### Proposed Revisions to a Standard Plans Index

Index Number: 515-022

Sheet Number (s): 3 of 3

Index Title: Pedestrian/Bicycle Bullet Railing Details

INDEX  
515-022

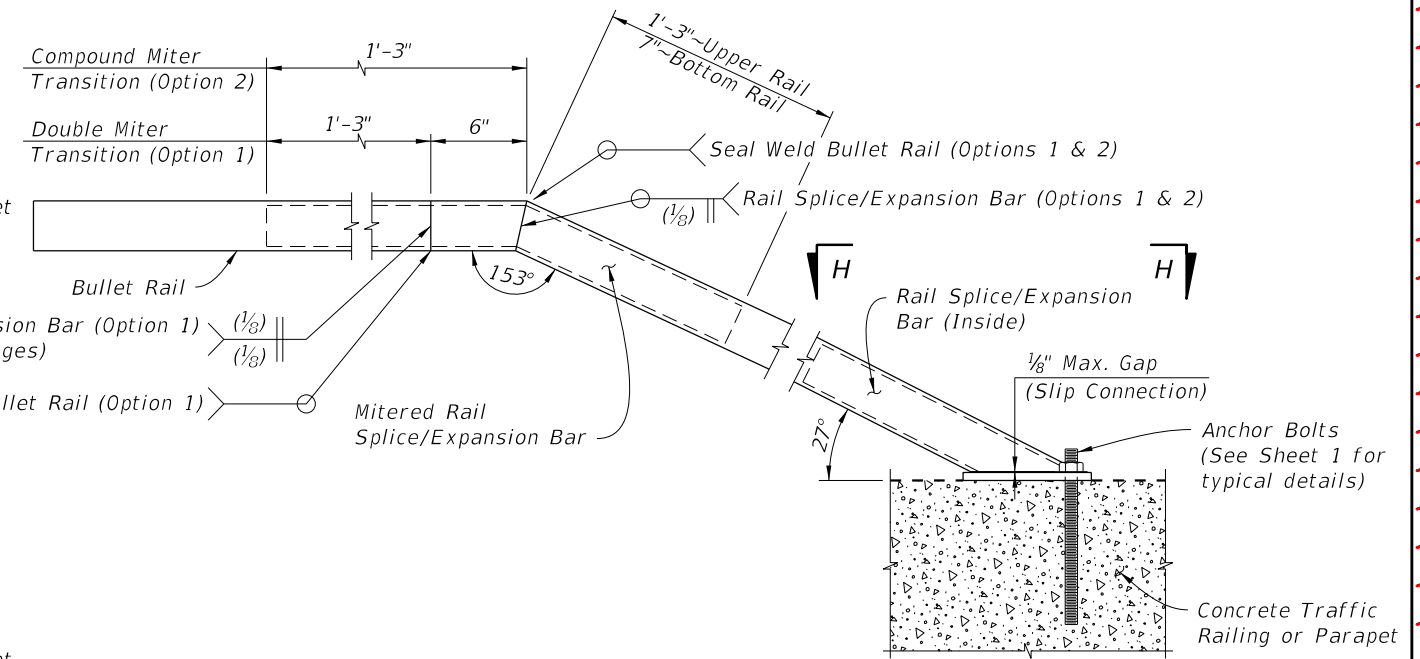
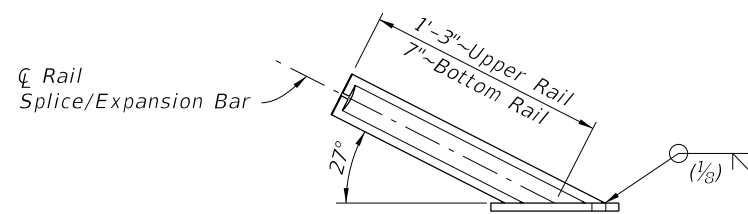
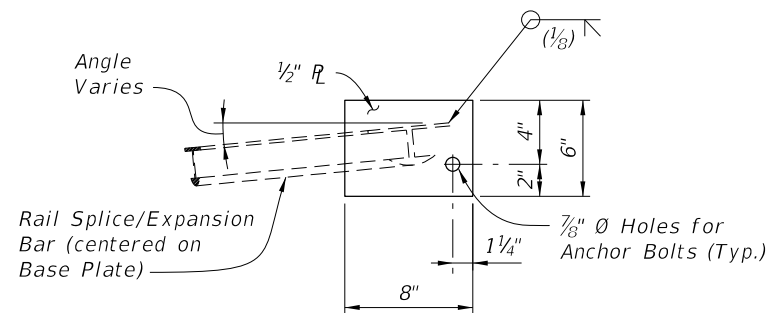
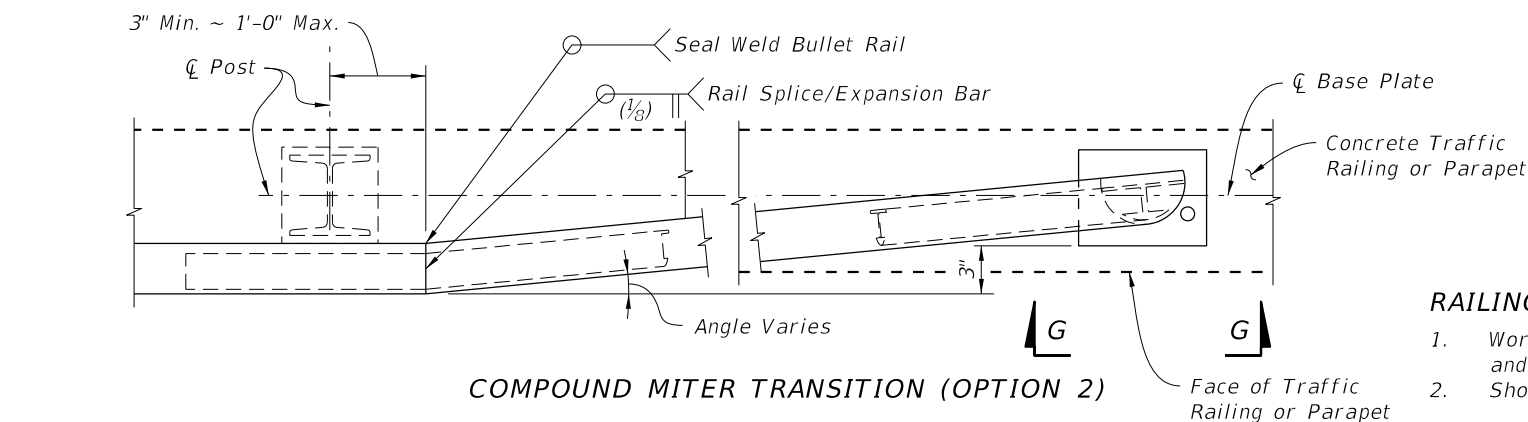
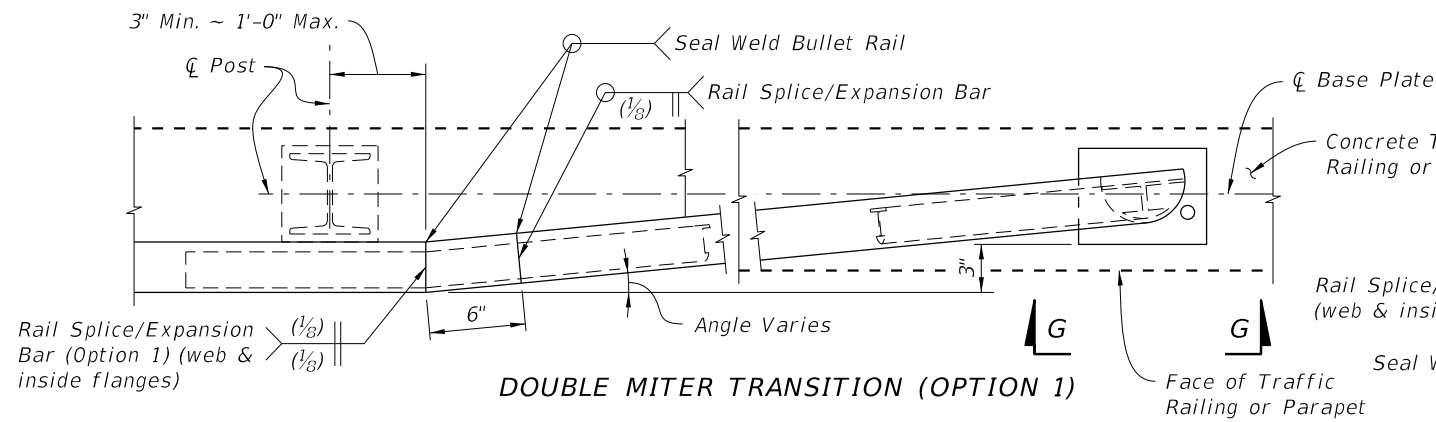
Sheet 3: Corrected the relative location and dimensions of the base plate and post with respect to the edge of the bullet rail.

Dimensions and drafting associated with the rail were corrected to reflect its correct orientation. The rail had been drafted as if it were facing down in plan which was incorrect.

Edited details to correct the orientation of the rail.
